CONSTRUCTION TRAFFIC MANAGEMENT PLAN

Sydney Metro West – Western Tunnelling Package

Clyde/ Rosehill Site Establishment

Document Title	Clyde/ Rosehill Site Establishment
Project Name	Sydney Metro West – Western Tunnelling Package
Client	Sydney Metro
Document Reference No.	SMWSTWTP-GLO-CLJ-TF-PLN-000001
Revision Date	<u>6 May 2022</u>

Figure 2-3: Existing sensitive receivers

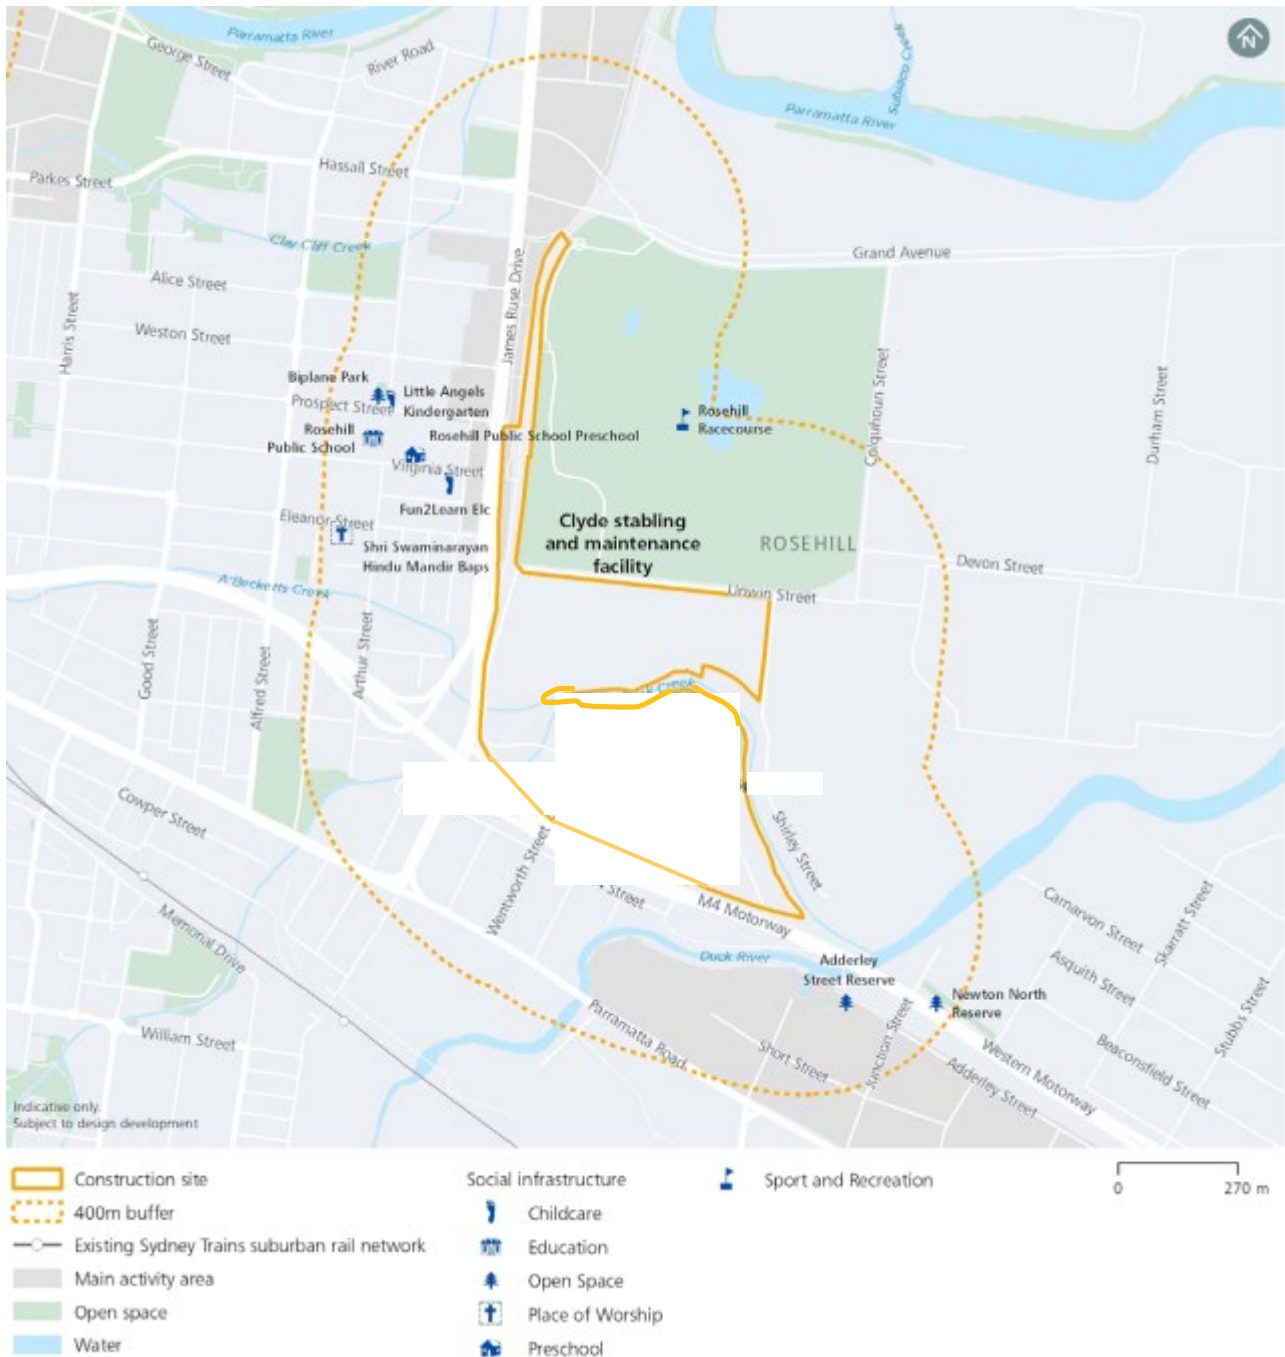
17	22/04/2022	SMD	ISUBRAMANI	SMWSTWTP-GLO-CLJ-TF-PLN-000001	figure 3 page 9	na	former sydney speedway -as Sydney Metro have acquired this land & facilitated their relocation.	Observation	N
							D KELLY	SMWSTWTP-GLO-CLJ-TF-PLN-000001	figure 3 page 9	na	Document amended	Observation	N
				18	22/04/2022	SMD	ISUBRAMANI	SMWSTWTP-GLO-CLJ-TF-PLN-000001	figure 4 page 10	na	What are the requirements for WTP to assess sensitive receivers and update since EIS?Remove references to sport and recreation within the project site. No longer relevant.	Observation	N
							D KELLY	SMWSTWTP-GLO-CLJ-TF-PLN-000001	figure 4 page 10	na	A land use survey is included as part of the detailed Noise and Vibration Impact Statement (SMWSTWTP-GLO-1NL-NL000-NV-PLN-000002). This is currently in draft and is being informed by construction from the EPA and other stakeholders. Throughout the construction period this document will be an evolving document.	Observation	N

TRAFFIC CONTROL PLAN DATE: 19/03/2022 R.1	Area:	CLYDE
	Location:	SHIRLEY ST
	TCP No:	TGS-CLY-SHI-SB-1202
	Sheet No:	1 OF 1

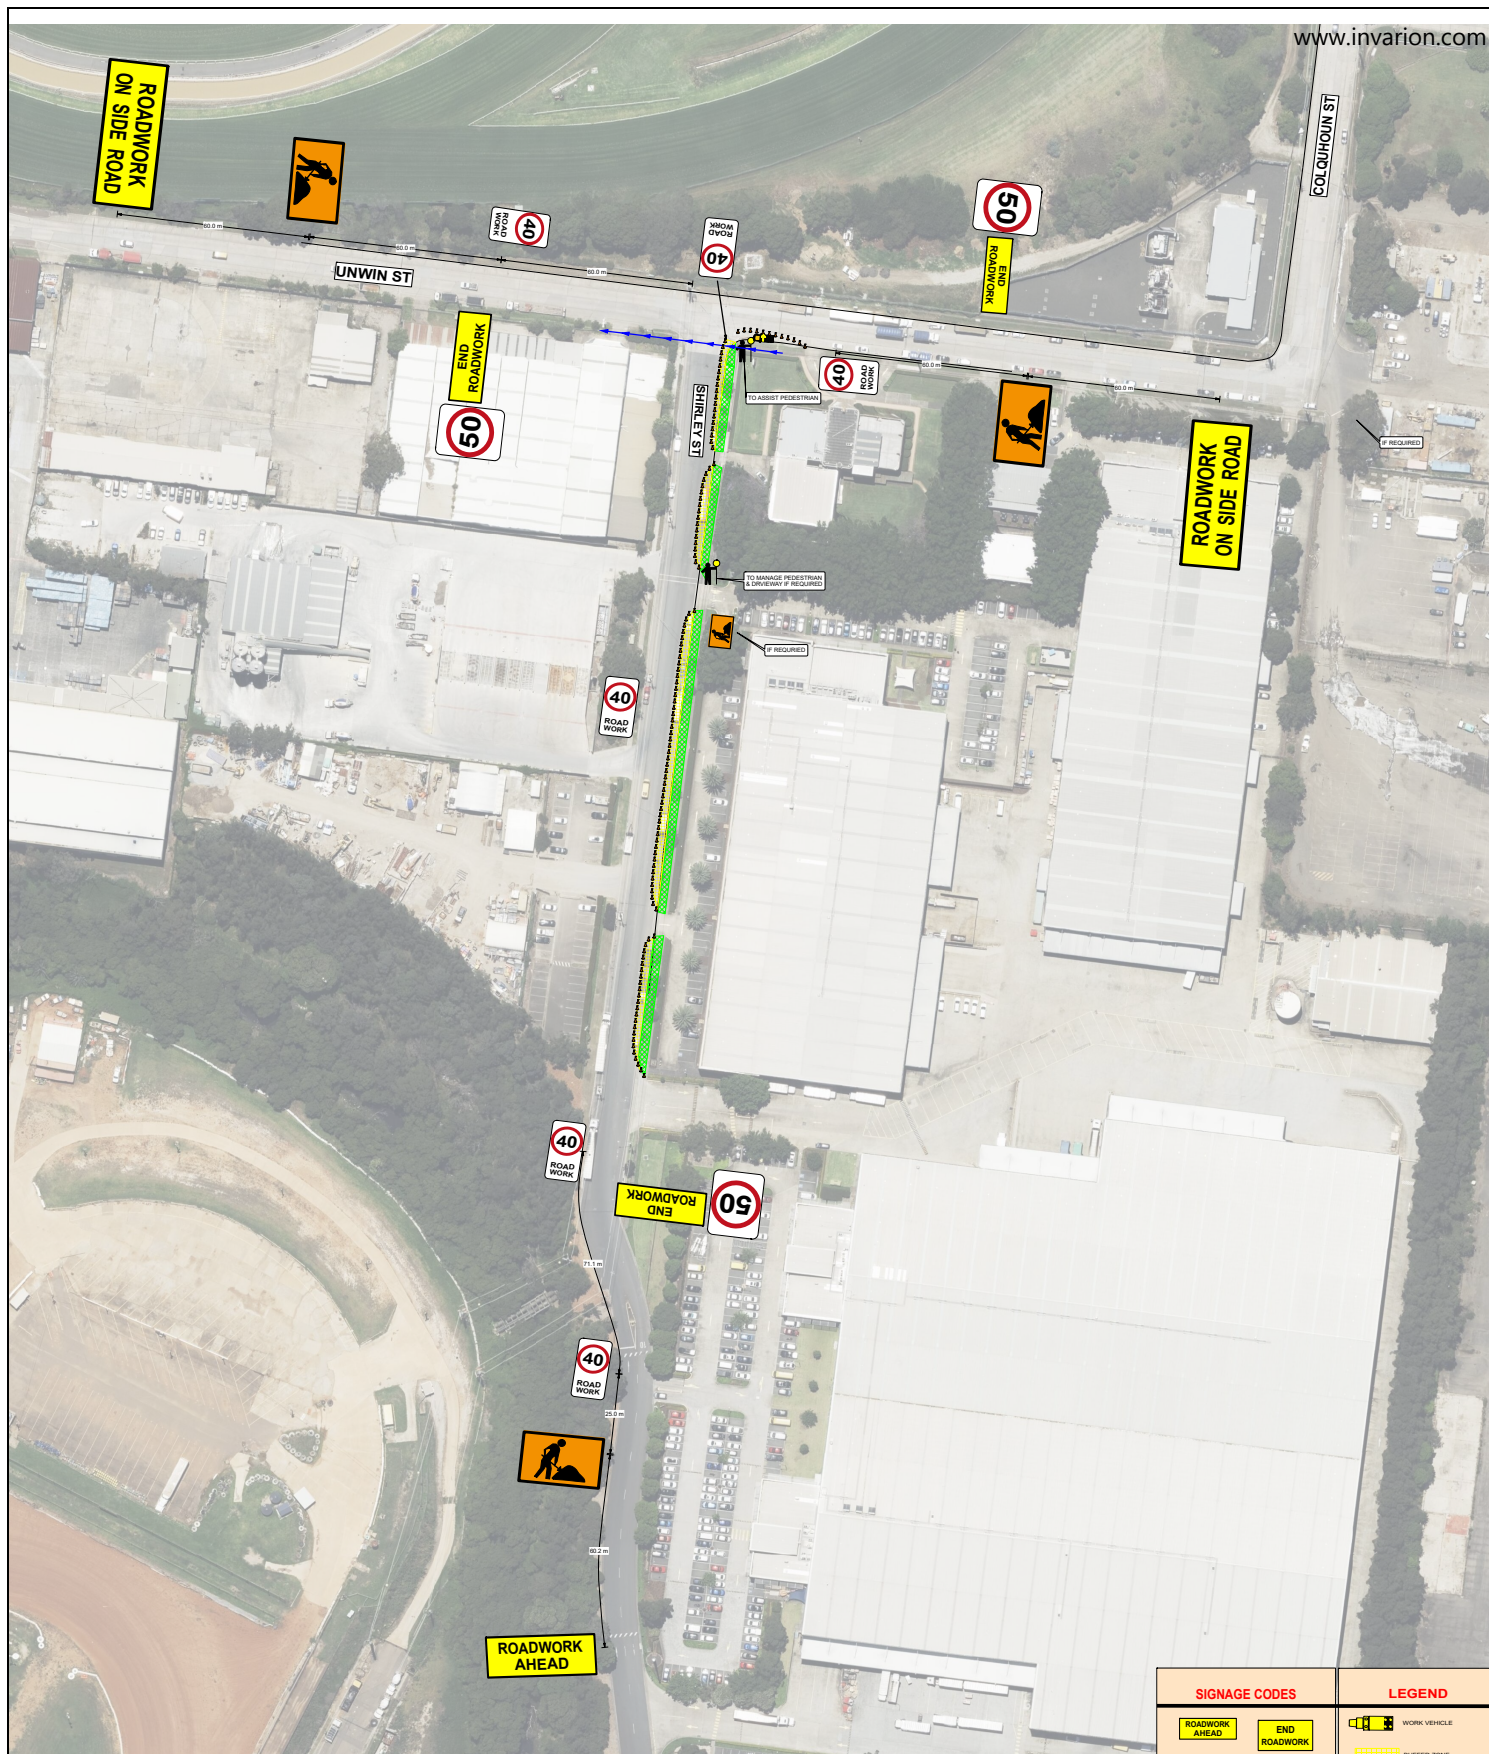
Sydney Metro West – Western Tunnelling Package Clyde Site Establishment				
	Audit Point	Treatment Option	Sue Lewis Consulting Responder:	
			Response ^x	Status ^y
TGS-CLY-SHI-NB-1201

Area:	CLYDE
Location:	UNWIN ST
TCP No:	TGS-CLY-UNW-EB-2201
Sheet No:	1 OF 1

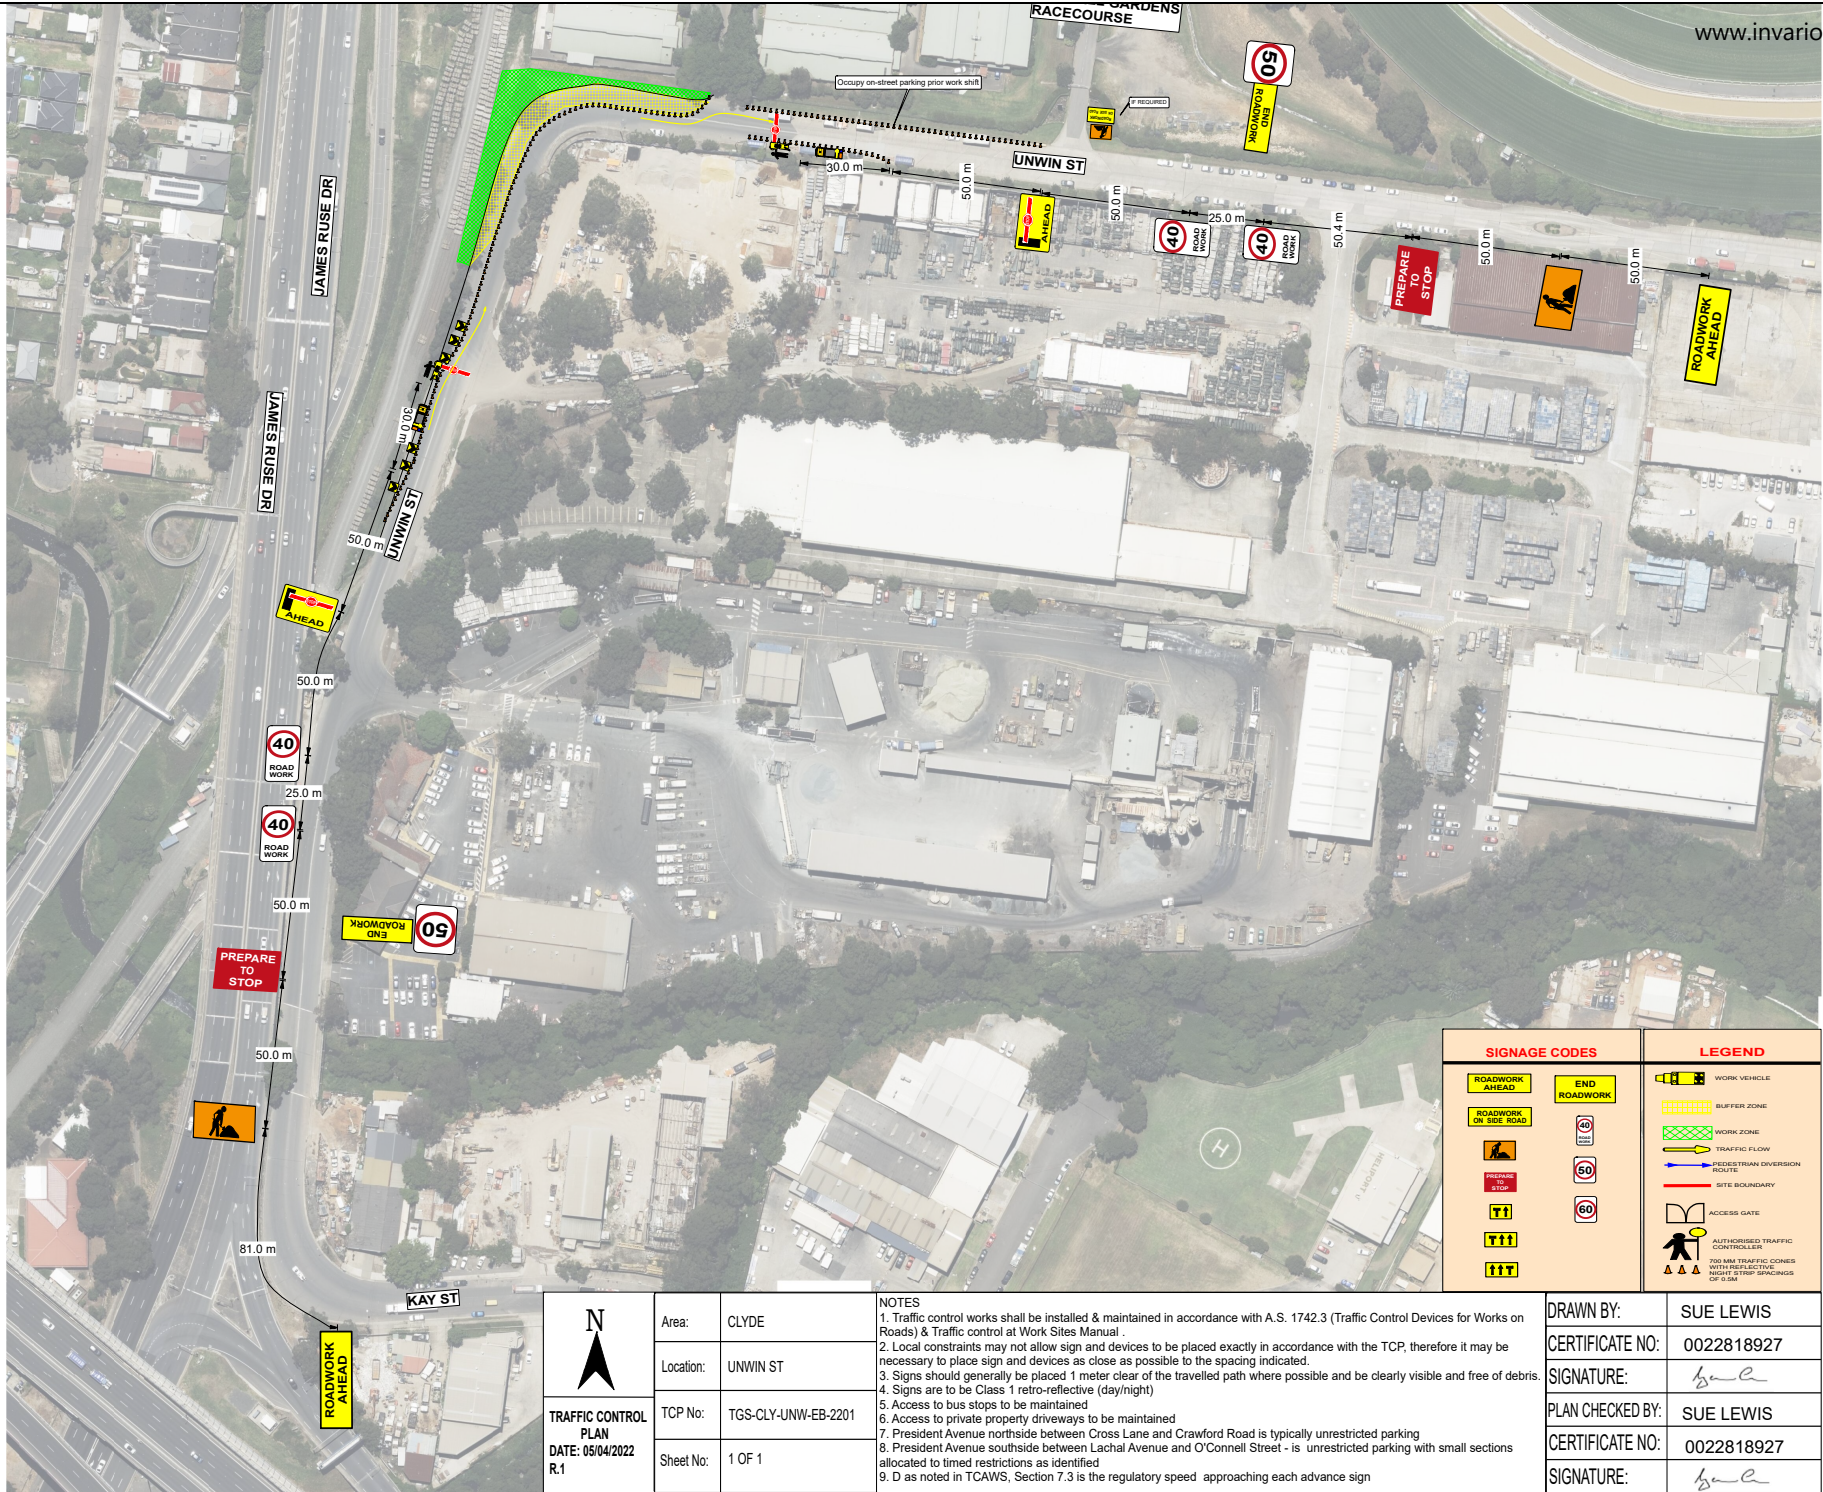
Audit Point	Treatment Option	Sue Lewis Consulting	
			Responder:	
			Response ^x	Status ^y
TGS-CLY-UNW-EB-2203				
10.	There is no requirement for westbound traffic on Unwin Street to change lanes at the eastern limit of works. The proposed lateral shift sign and flashing arrow may add to unnecessary driver confusion.	Omit the flashing arrow and sign shown circled in red below. Risk: Low	TGS amended	Closed

Area: CLYDE
Location: WENTWORTH ST
TCP No: TGS-CLY-WEN-SB-1201
Sheet No: 1 OF 1

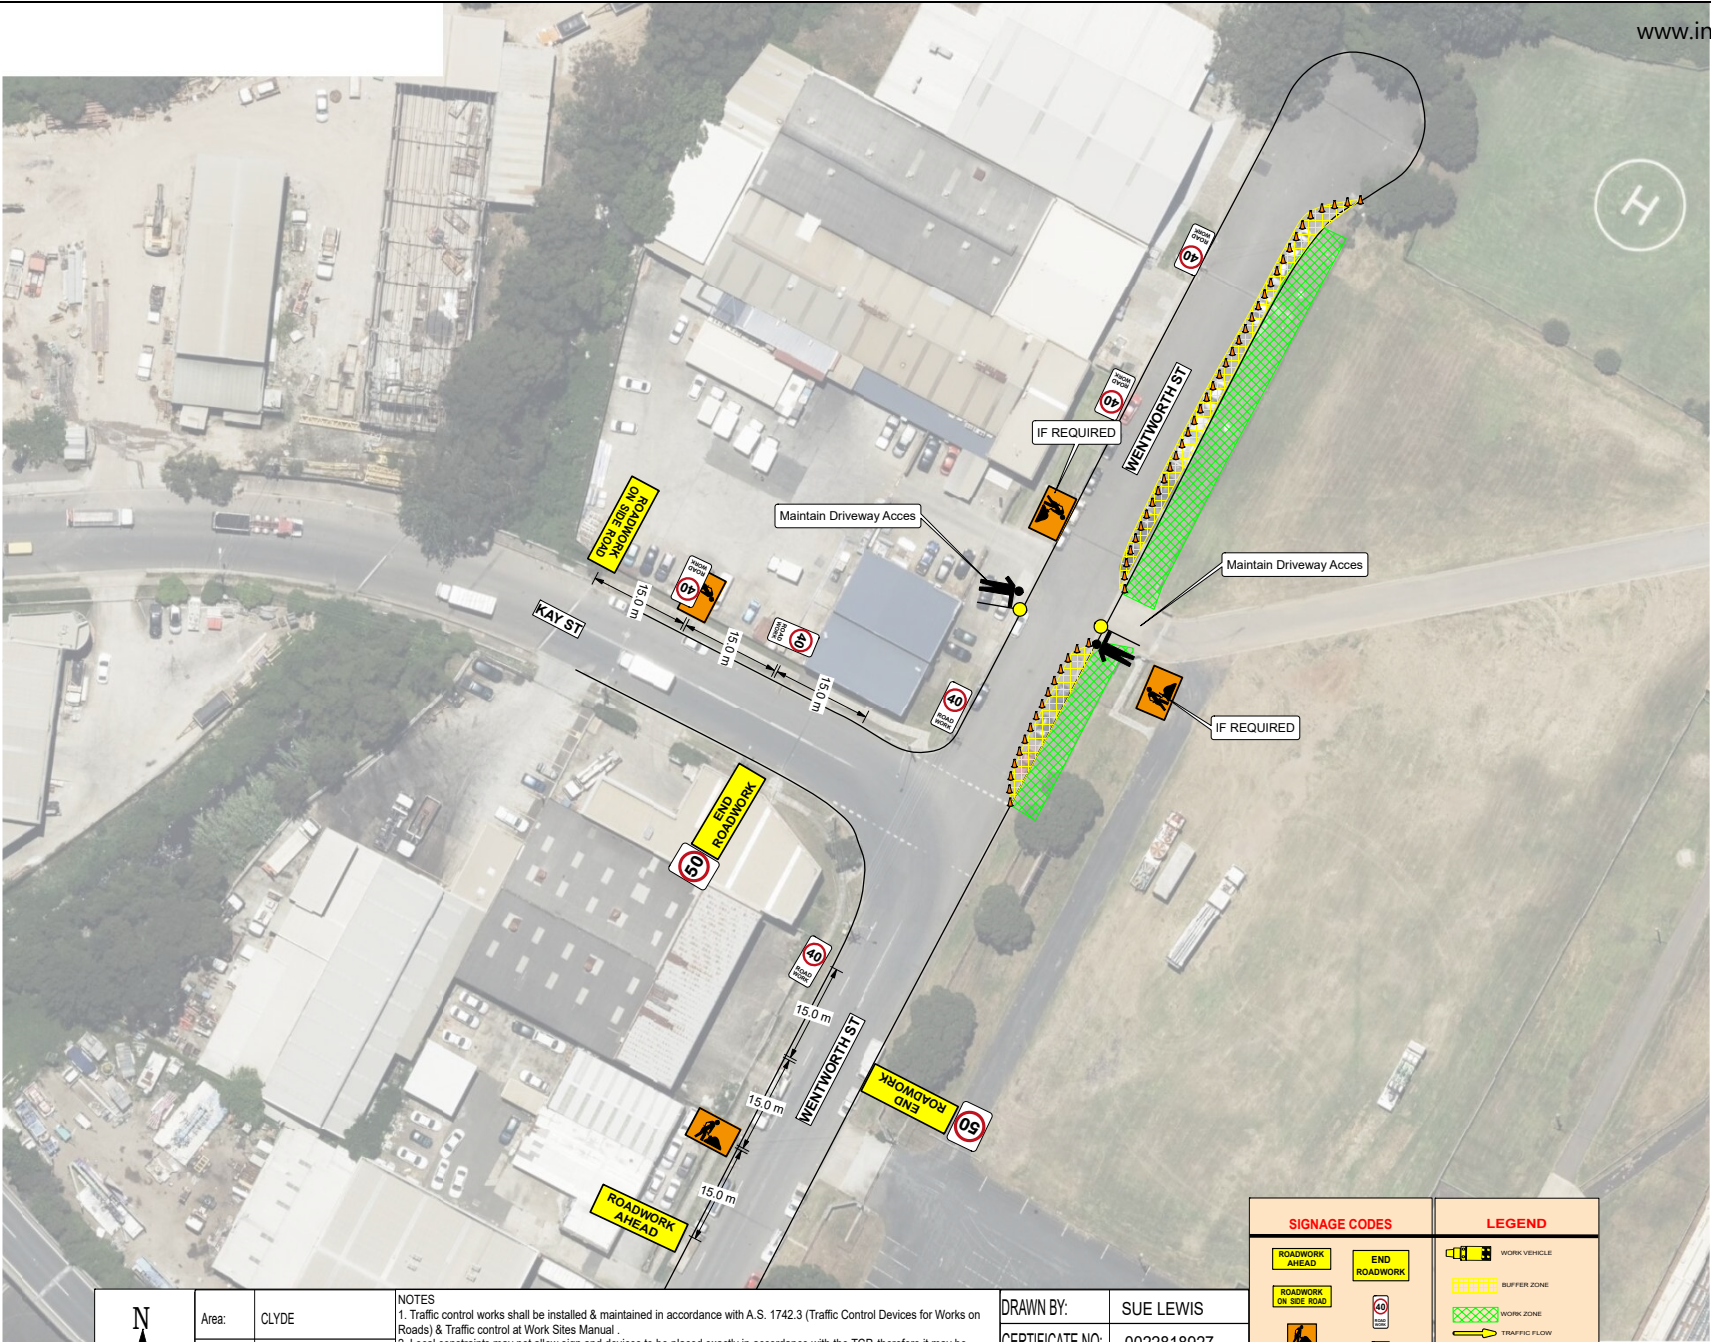
Audit Point	Treatment Option	Sue Lewis Consulting	
			Responder:	
			Response ^x	Status ^y
TGS-CLY-WEN-SB-1201				
23.	No road safety issues are identified. However, there is potential for parked vehicles along the kerb on Wentworth Street to obscure proposed advance warnings signage.	Review whether the proposed signs can be obscured by parked vehicles. It may be necessary to post mount the signs or ban parking where advance signage is proposed. Risk: Low	To be monitored during installation	Ongoing
